PROJECT : BW2
Quanta Computer Inc.

Revision History

PROJECT : BW2	
		Quanta Computer Inc.	
Size Custom	Document Number	EC RECORD A-1	
Date: Thursday, March 02, 2006	Sheet 77 of 79	Rev	3B

CLOCK GEN ICS954309

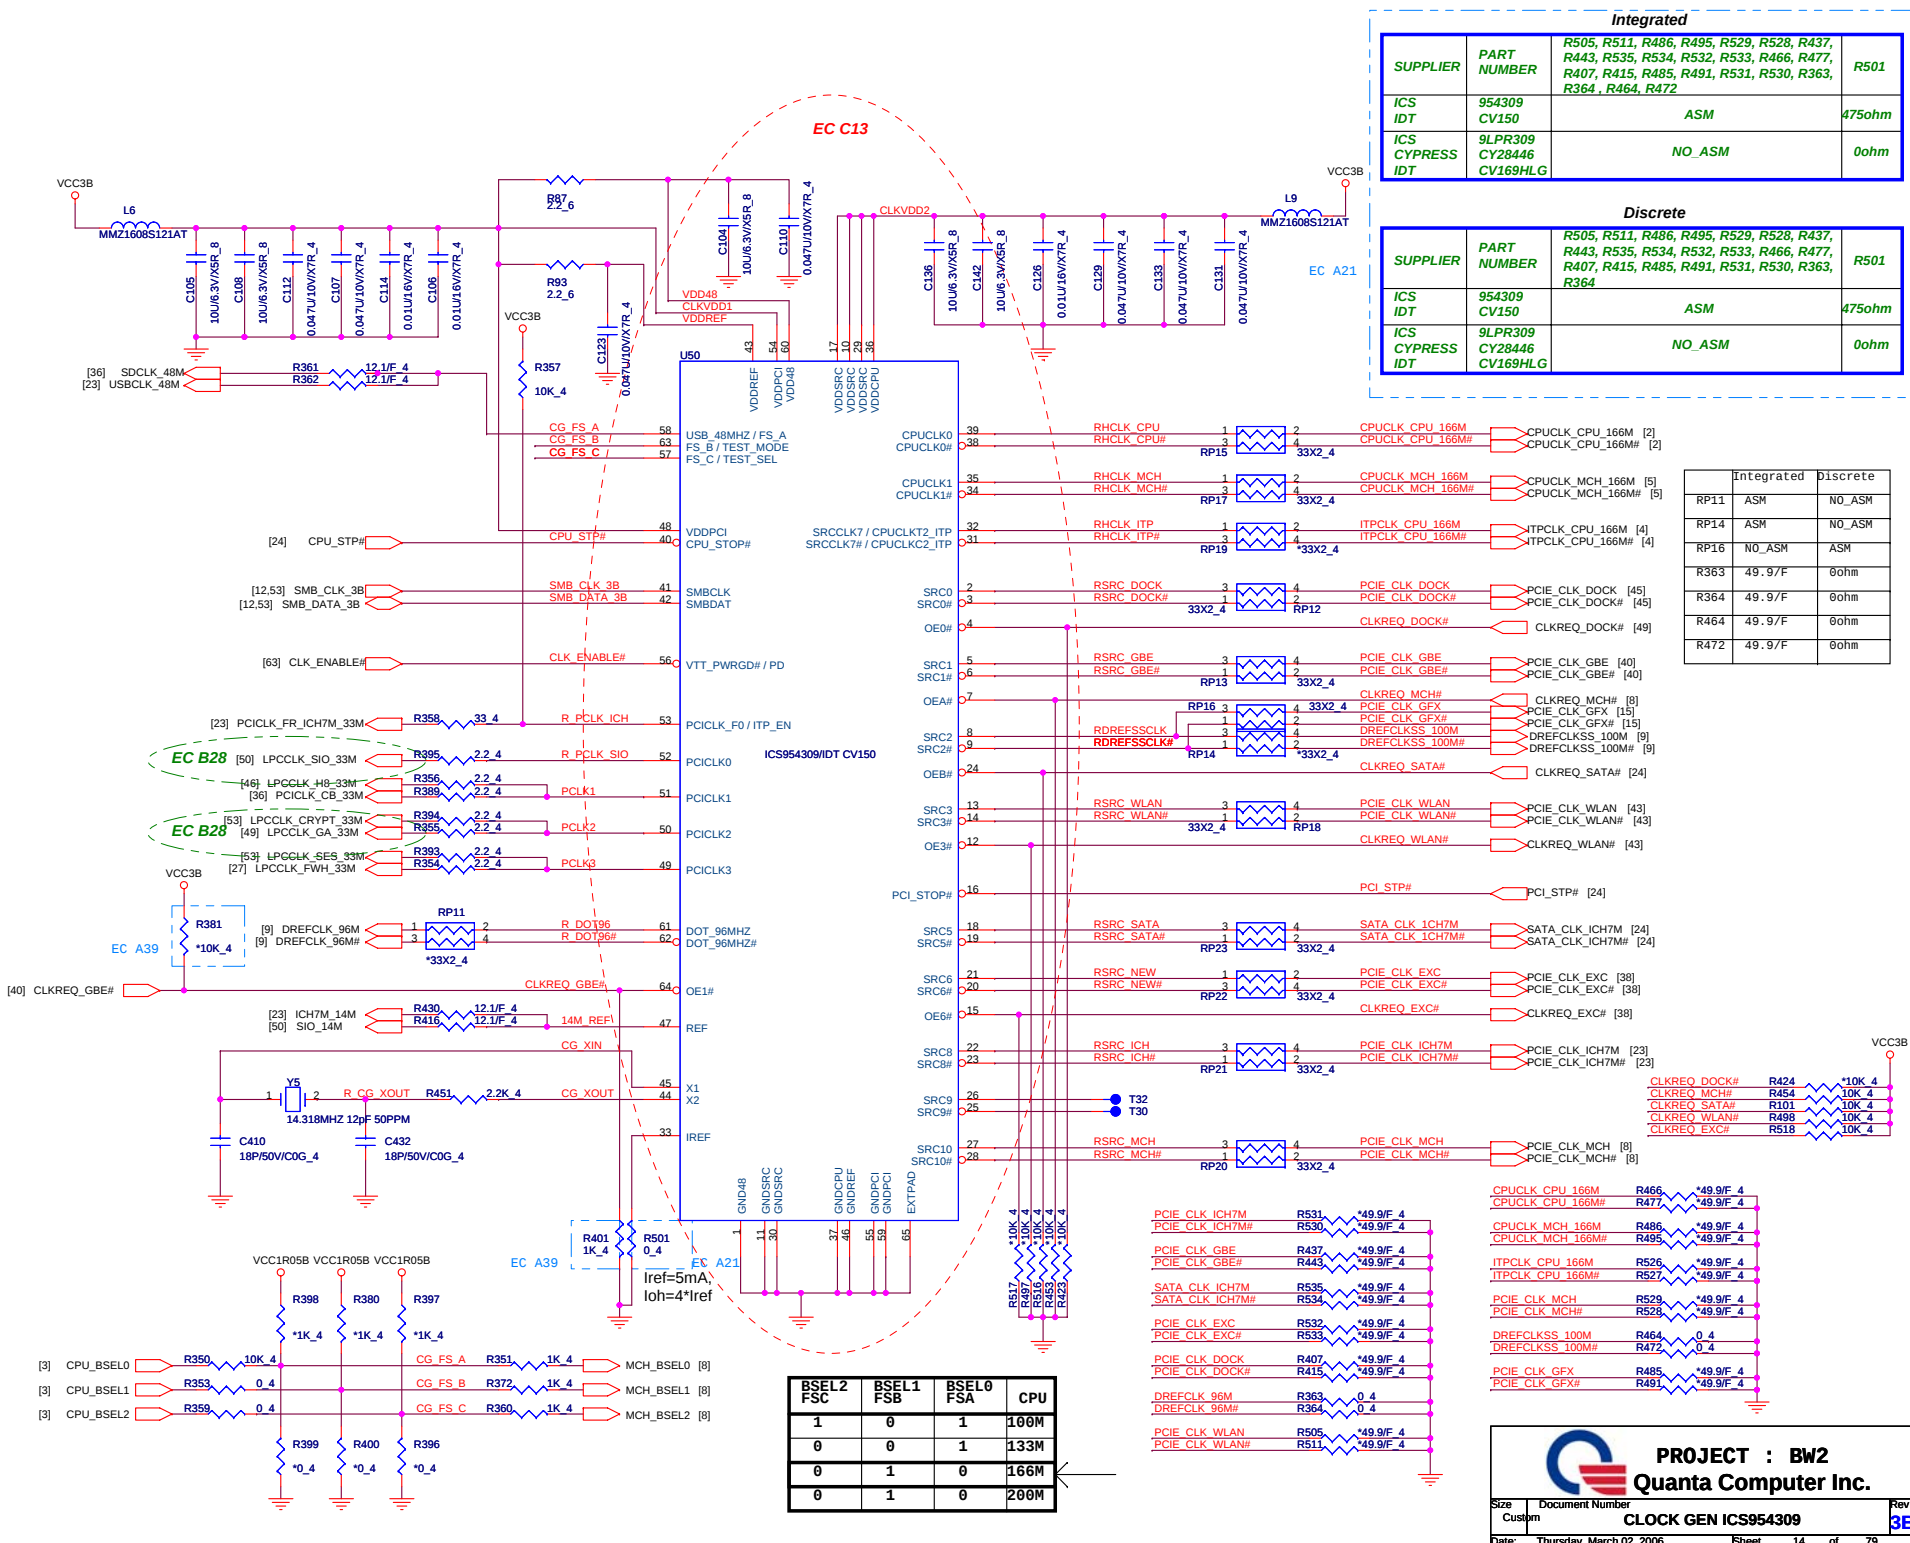
EC A21/14/R501 475/F ohm change to ASM for CLKGen parts and R501 0 ohm change to ASM for CLKGen low-power parts from SIV-Lenovo-002.

- EC B27/32/33/ Audio noise reduction. (SIT-LENOVO-031)
- EC B28/14/ Swap PCI clock for PMH7/SIO , the reason is for rising / falling time fail issue.
- EC B29/65,66,67/ Delete PL18,PL16,PL17,PL2 bead.

- EC C12/62,66 Connect MAX1977_PWRGD to MAX1540 , the reason is minus voltage issue. (SVT-LENOVO-012)
- EC C13/14 Drop Cypress clock generator sourcing , the reason is SATA signal spec off. (SVT-LENOVO-018)

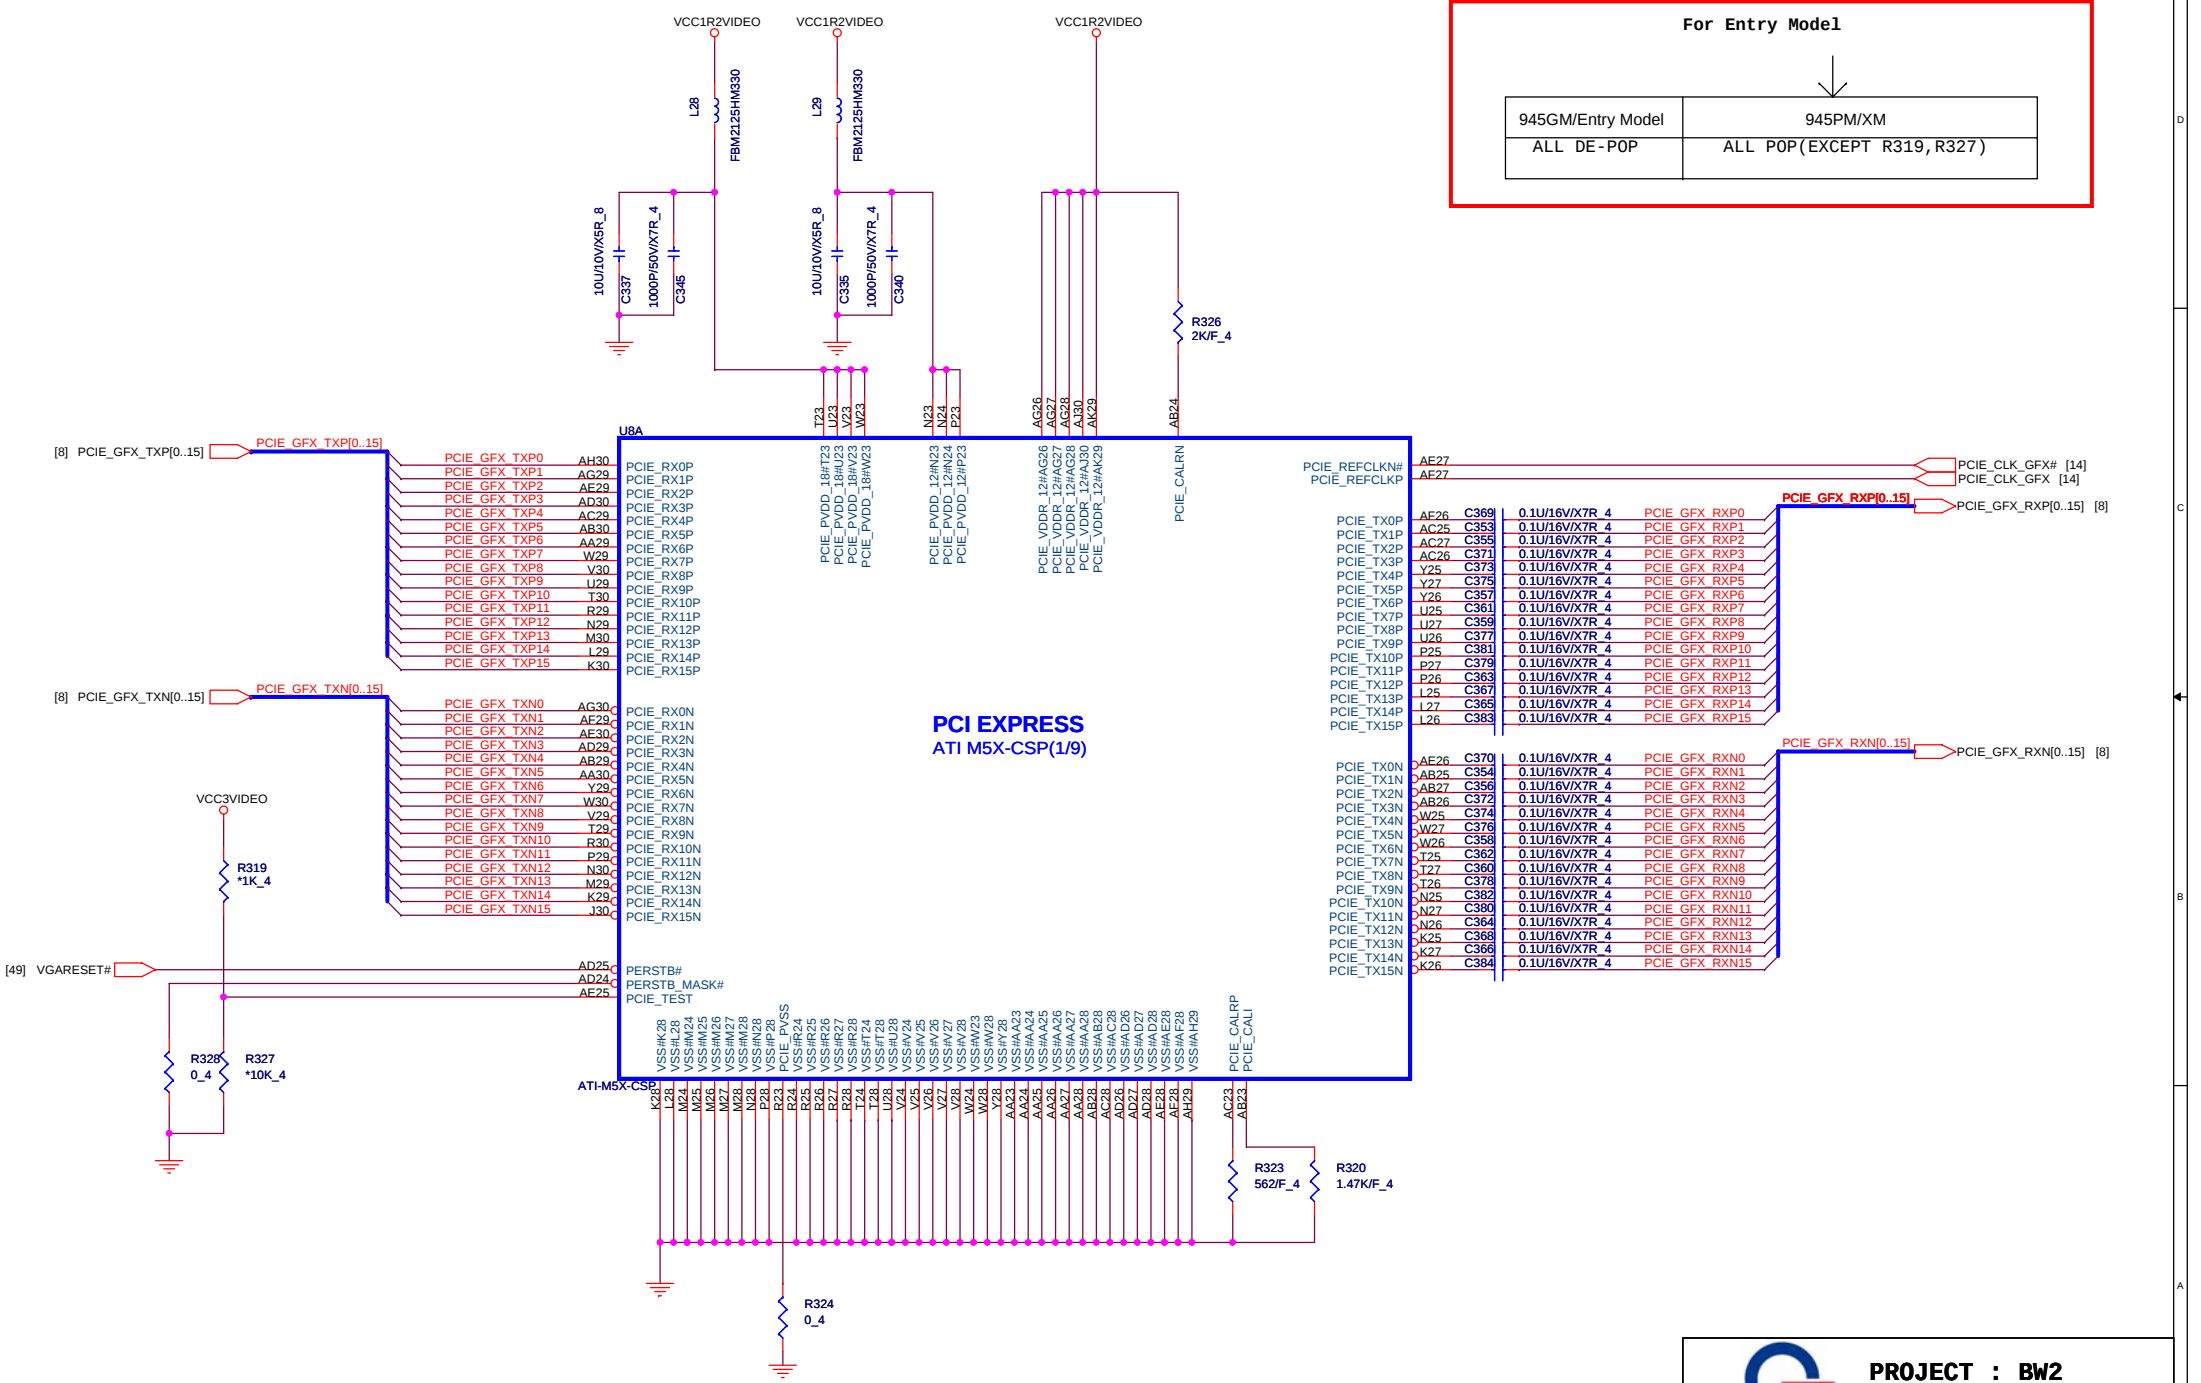
EC B33

- EC B33/17 Add crystal oscilator circuit. (SIT-LENOVO-036)
- EC B34/50 Add FUSE for USB hub sub card. (SIT-LENOVO-035)
- EC B35/67 Change VCCVIDEOCORE voltage. (SIT-LENOVO-034)

- EC B40/17/ Change C347,C350 from 22pF to 2pF.
- EC B41/43/ Add one power pin for UIM_PWR net of connector.
- EC B42/10/ Add one cap 10/10V/X7R for VCCA_TVBG "H20" pin , the reason is while output to TV have ripple screen for Intel model.

Configuration Chart

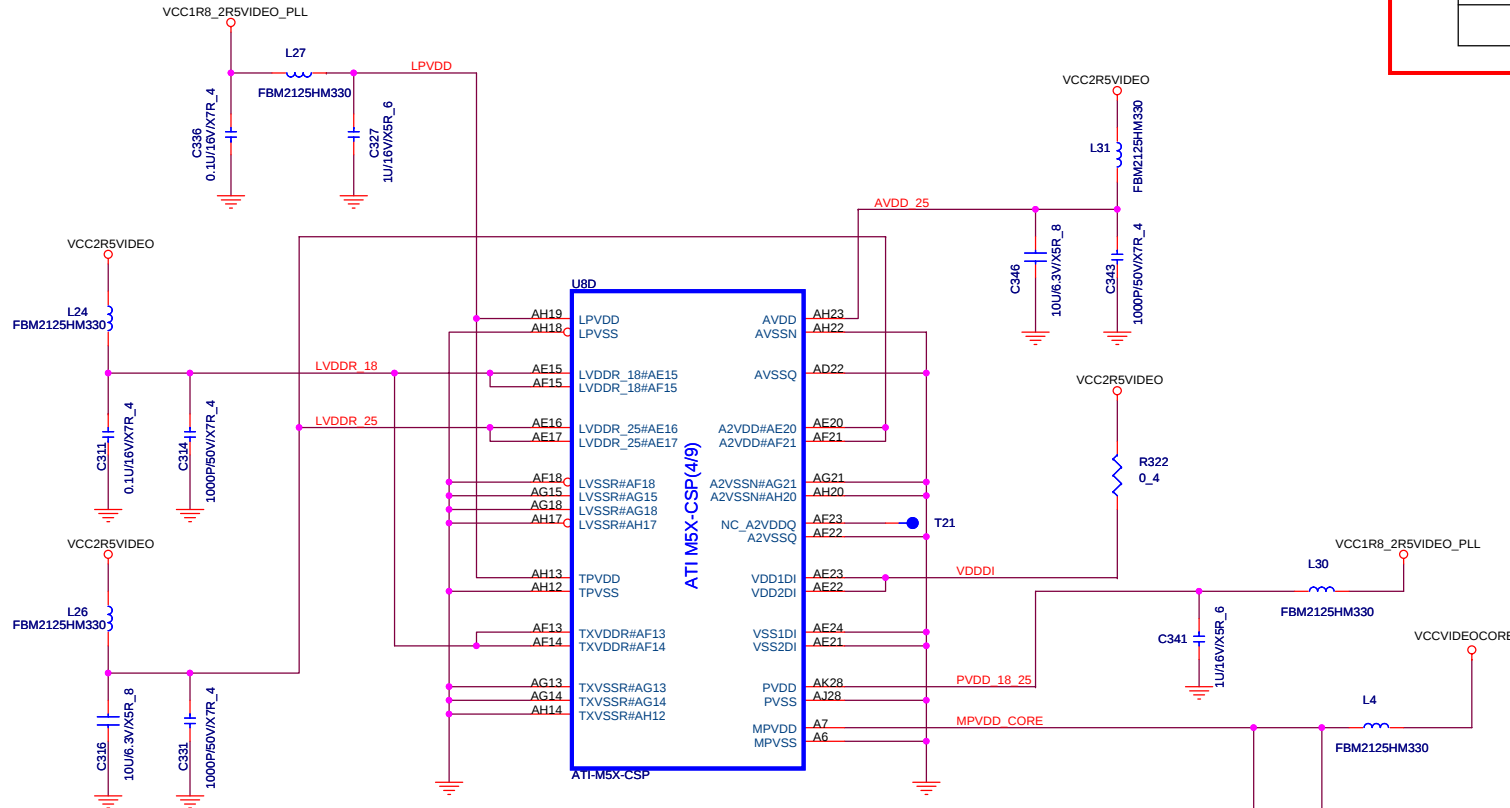
EC A65
EC B13

EC B19

- EC A64/16/R318 75/F ohm change to ASM and R321, R315 150/F ohm change to ASM for TV function.
- EC A65/18/Modify VCC1R8_2R5VIDEO_PLL LDO circuit for ATI M52/M54/M56.

- EC B13/18/ Change LDO to MAX8875EUK25-T for ATi M52/M54. (SIT-LENOVO-014)
- EC B14/19/ Change U57 power source from VCC3VVIDEO to VCC3M. (SIT-LENOVO-015)

- EC B17/17 Add pull-down 10k at "GENERICD" signal. (SIT-LENOVO-020)
- EC B18/33 Change U59 to MAX4695ETC+ Pb free part. (SIT-LENOVO-021)
- EC B19/18 Correction U43 RoHS part number. (SIT-LENOVO-022)

PCI Pullups

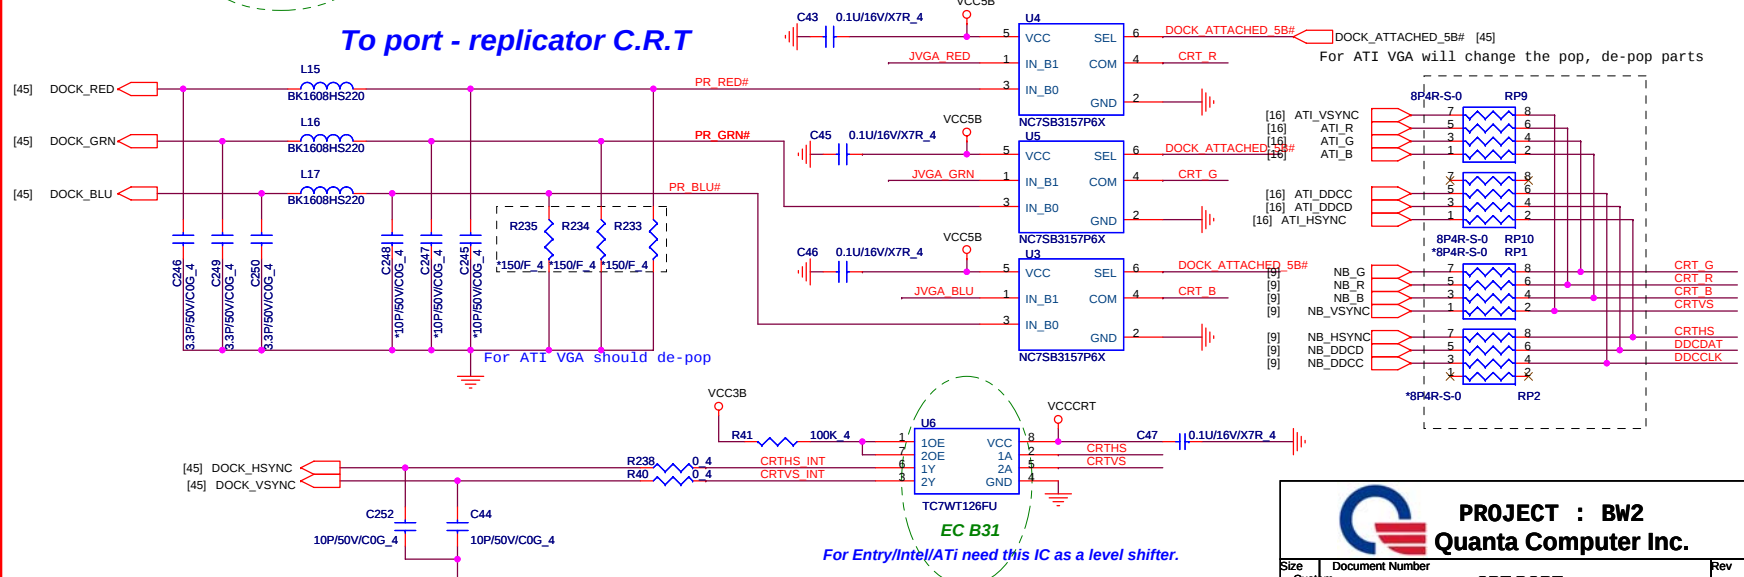
EC B31

- EC B30/31/32 Modify audio jack sense circuit.
- EC B31/22 Modify CRT circuit for Entry/Intel/ATi model. (SIT-LENOVO-033)
- EC B32/21 Add ESD cap for stereo Mic signals. (SIT-LENOVO-037)

Macronix MX25L1605A

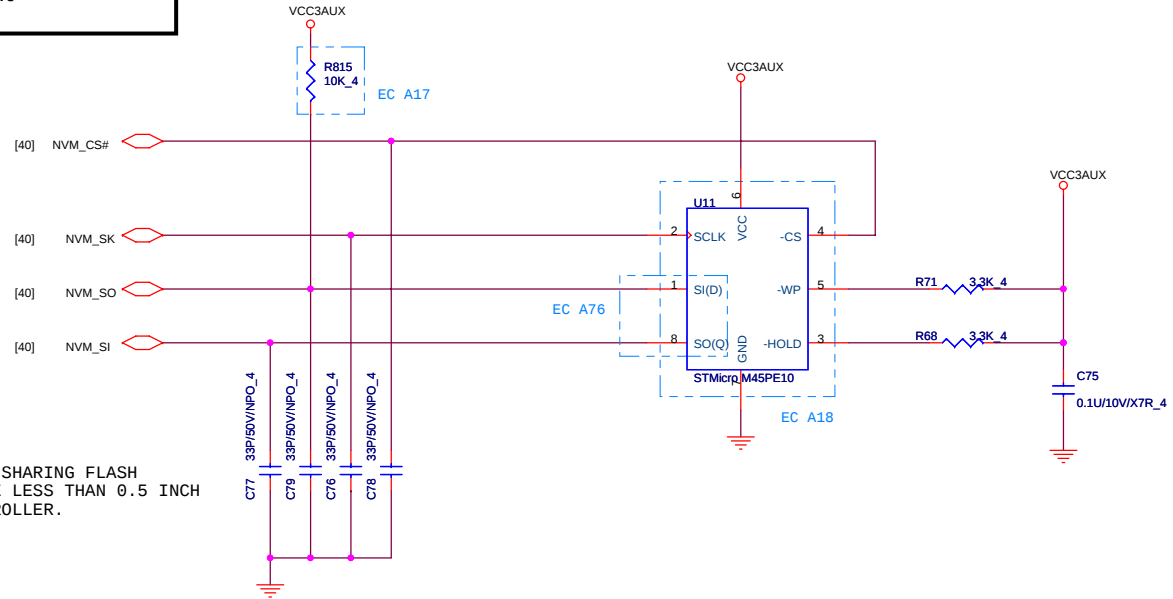
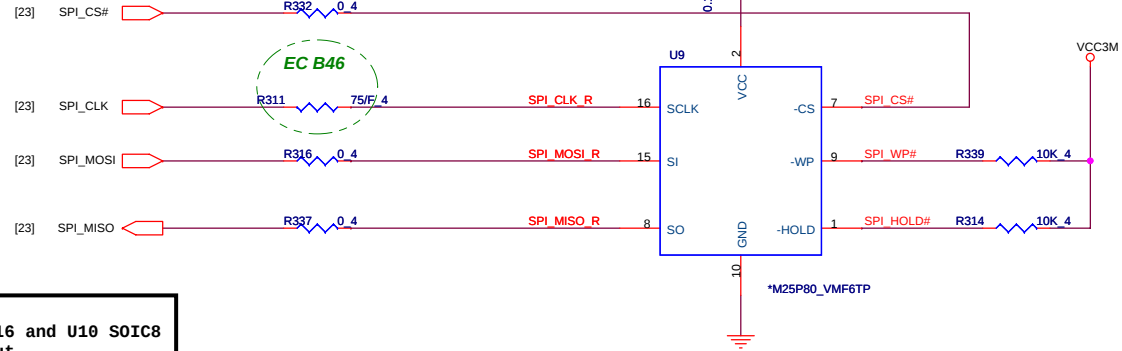
EC A89

- EC A87/60/PR176 2K/F ohm change to ASM for Entry Model from SIV-Lenovo-044.
- EC A88/65,66,67/PL2, PL16, PL17, PL18 from Bead change to 0 ohm.
- EC A89/44/U10 from ST M25P80 change to Mocronix MX25L1605A.
